TITLE: **SPECIAL PERMIT NO. 2017, Maple Village Community Unit Plan**, requested by Brian D. Carstens and Associates on behalf of Mike Moser, for **32** attached single-family units and **3** single-family units, and associated waiver requests, on property generally located southwest of the intersection of Cherrywood Drive and Sycamore Drive.

LINCOLN CITY/LANCASTER COUNTY PLANNING STAFF REPORT

P.A.S.: Change of Zone #3407 from R-2 to R-3
Special Permit #2017 for a Community Unit Plan for 37 35 Dwelling Units

To: Brian Will, Planning Department
From: Chad Blahak, Public Works and Utilities
Subject: Maple Village
Date: 5/15/03
cc: Randy Hoskins
Devin Biesecker

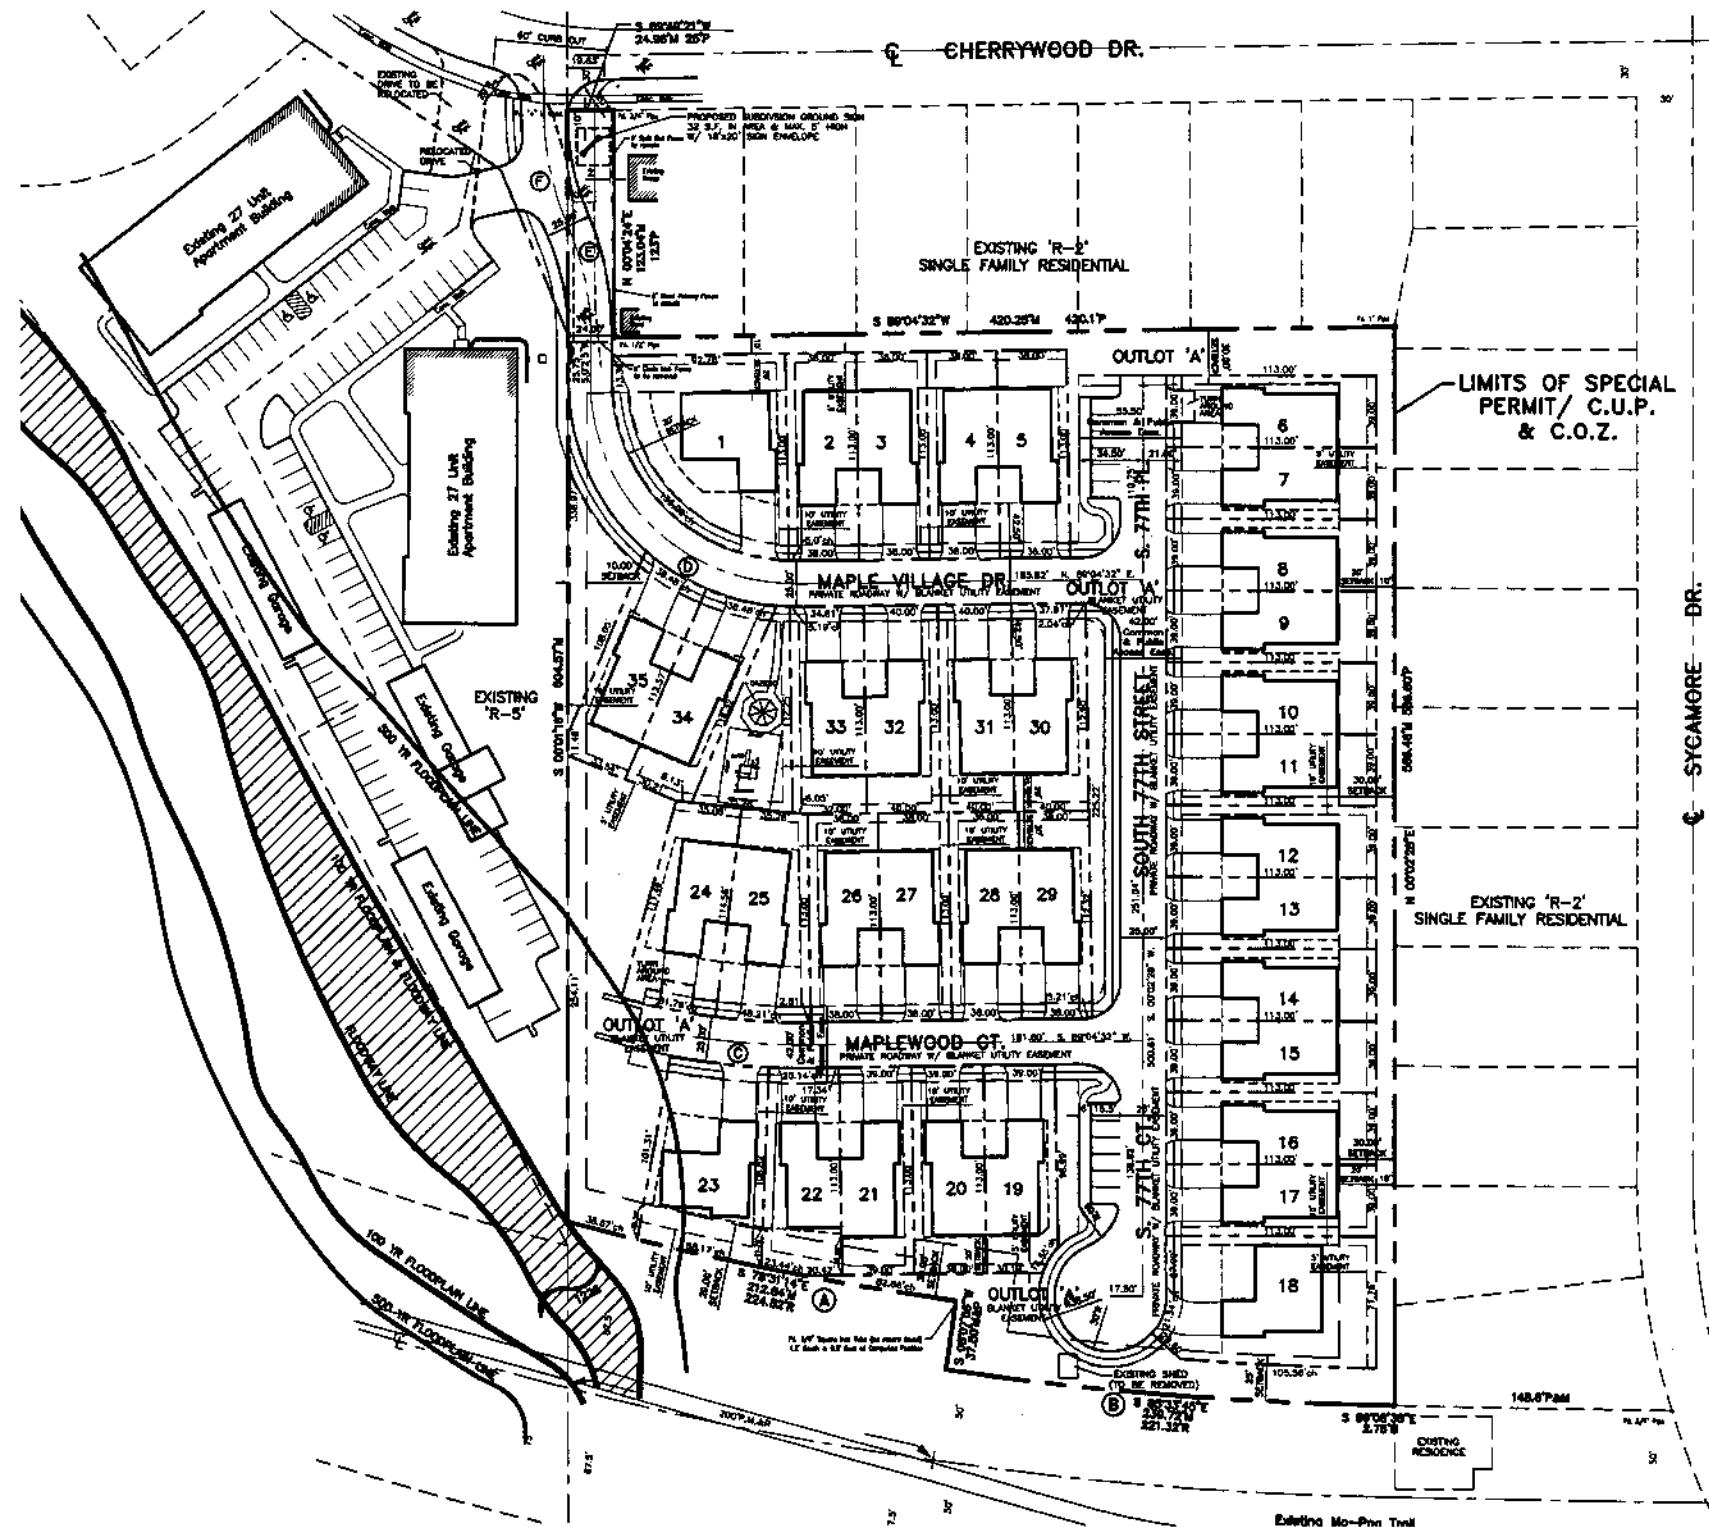
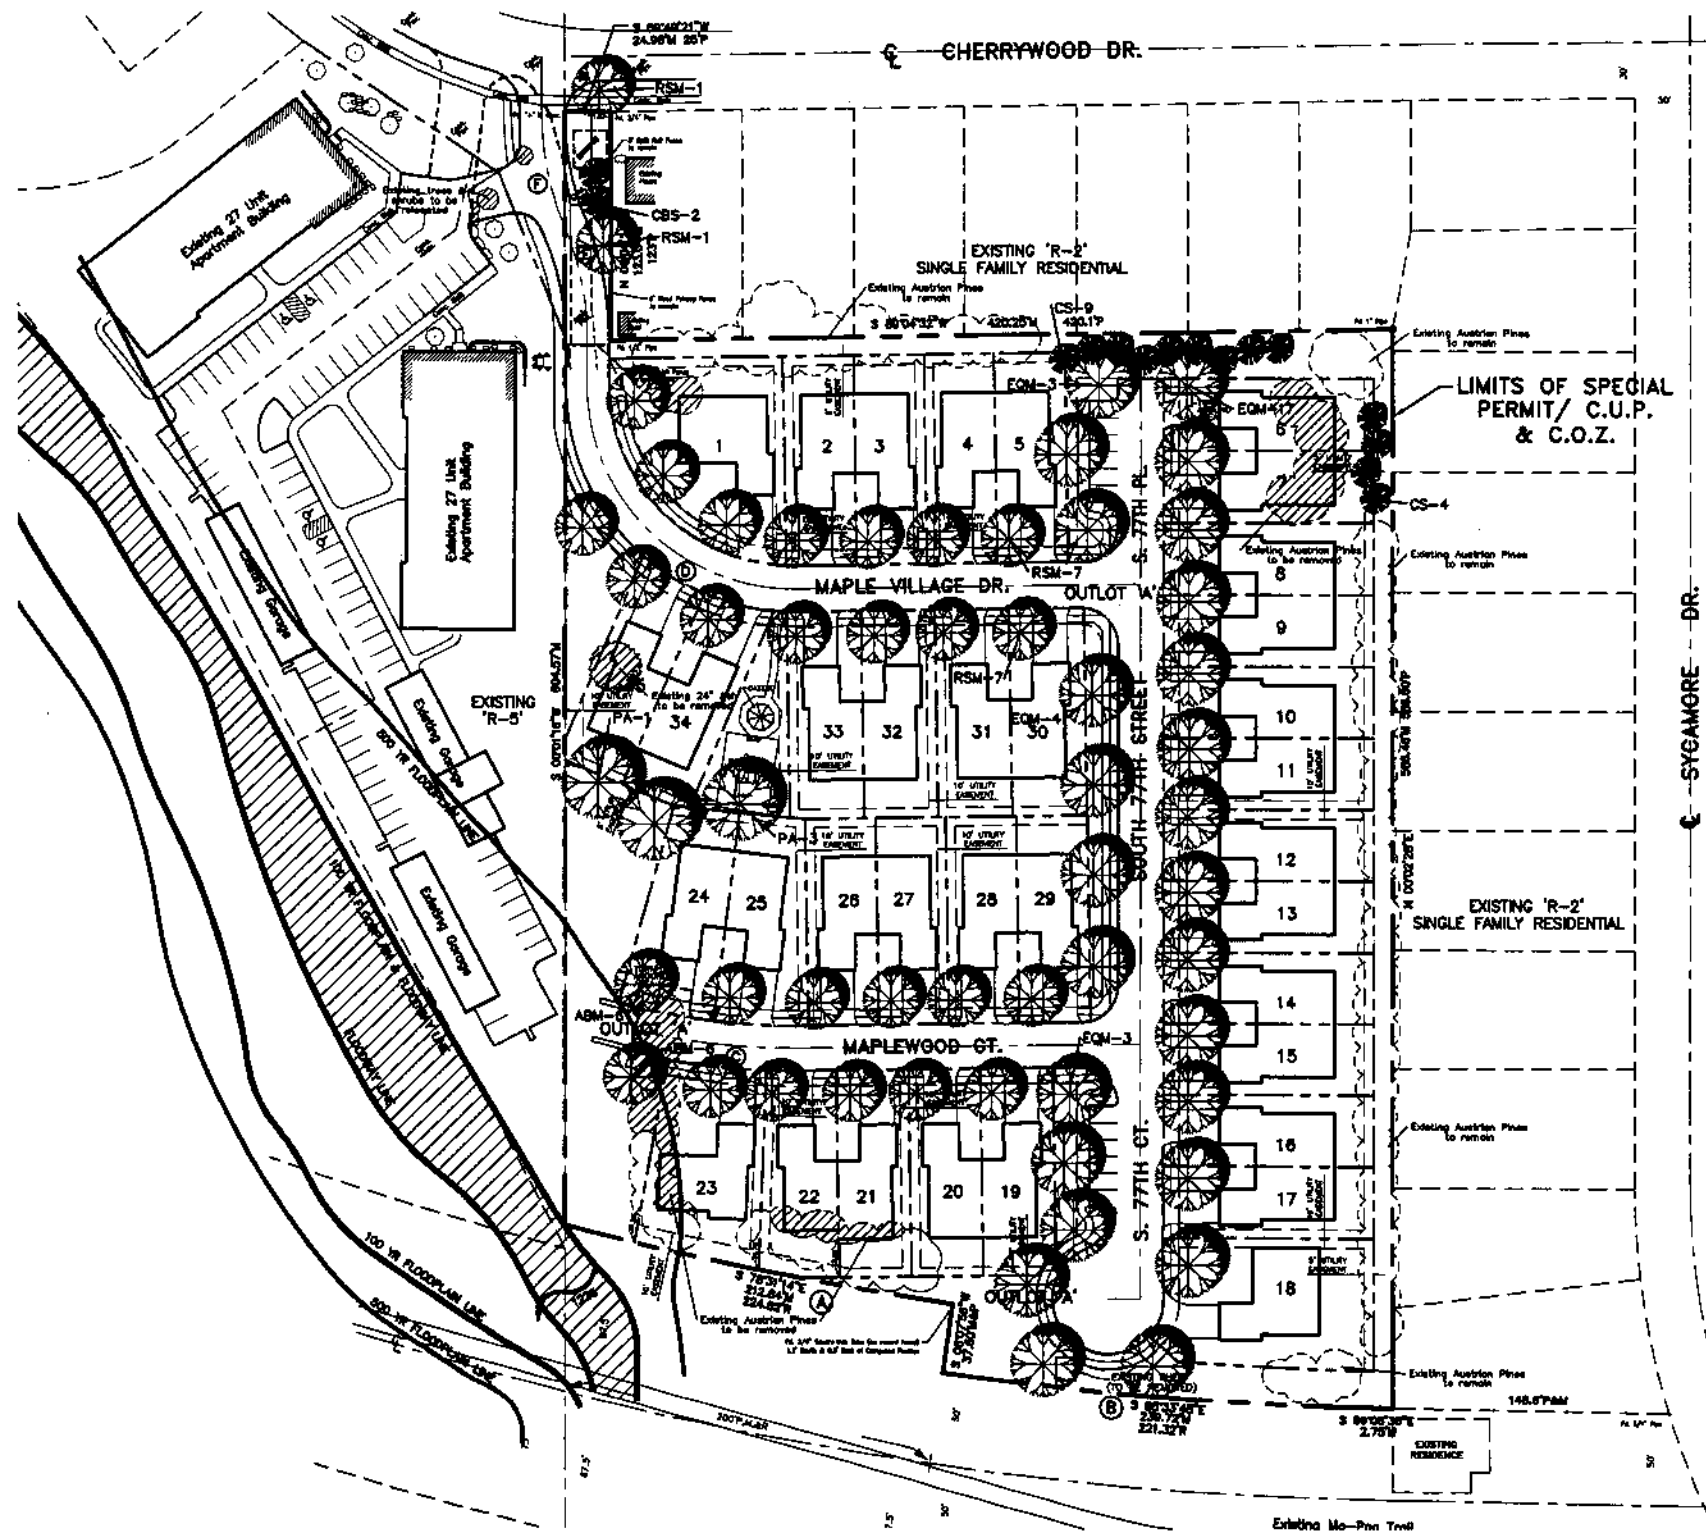
Sanitary - Show and label required sanitary sewer easements (minimum 30') for all proposed public sanitary sewer. Also show correct size for the existing sewer in the apartment complex to the west. The existing main is 18" not 8".

The water main south of Cherrywood Drive is located beneath the proposed paving and on the west side of the street, both contrary to design standards.

Streets - Design standards for private roadways state that a 27' wide roadway is required for all private roads that serve 30 or more parking spaces. All of Maple Village Drive and South 77th Street from Maple Village Drive to Maplewood Court is required to be 27' wide.

on This Maple Village Drive does not meet design standards for minimum tangent length for horizontal curves. A waiver needs to be requested for this exception to design standards. However, Public Works would not support this waiver. As shown the roadway is proposed to run next to an existing lot near the entrance to the development with the curb virtually the property line. This leaves no room for the required sidewalk, fence, or landscaping. is also the reason the water main is forced under the paving and on the opposite side of the street. It appears that the Maple Village Drive can be moved closer to the existing apartment building, away from the existing lot, and the entrance be reconfigured such that waivers for tangent length and curve radius standards are not required.

There are no turnarounds shown at the dead ends of Maplewood Court or 77th Place as per subdivision requirements.
